Revision Change Notice #1607291

PCN Date: 7/29/2016	Effective Date: 11/2/2016
Title: Si5340-41-42-44-45-46-47-48: Product Revision D	
PCN Type:	
<input checked="" type="checkbox"/> Datasheet	
<input checked="" type="checkbox"/> Product Revision	
PCN Details	
Description of Change:	
Silicon Labs is pleased to announce Revision D of the Si5340/41/42/44/45/46/47/48 devices and revision 1.0 of the corresponding datasheets and errata for these products.	
After the effective date of this PCN, customers should begin using Si5340/41/42/44/45/46/47/48 Revision D devices for all new designs and the older Revision B devices will be classified as "Not Recommended for New Designs" (NRND). At this time, Silicon Labs has no plans to EOL the Revision B devices and will continue to support them in full production along with Revision D.	
The changes from Revision B to Revision D of the Si5340/41/42/44/45/46/47/48 devices include the following:	
<ul style="list-style-type: none">• The maximum output frequency for Si5340/41/42/44/45 has been increased to 1.024GHz• The majority of the errata for Revision B of Si5340/41/42/44/45/46/47/48 have been resolved• Improvements have been made to the performanc

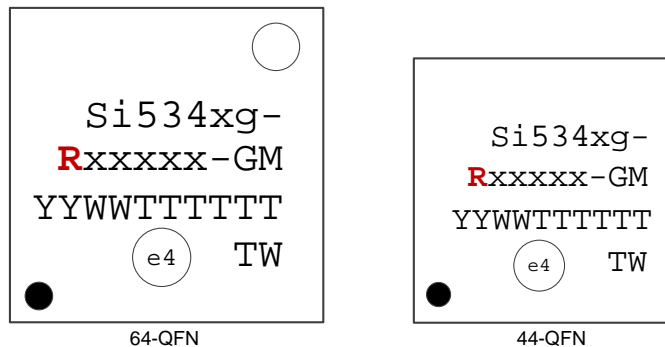
Form: The device top mark has been updated to reflect the change to Revision D. Refer to the diagrams below. For more information, refer to each datasheet’s Top Marking section, located at www.silabs.com.

- Device Revision B Top Mark: First character position (R) on line 2 below is a “B”.
- Device Revision D Top Mark: First character position (R) on line 2 below is a “D”.
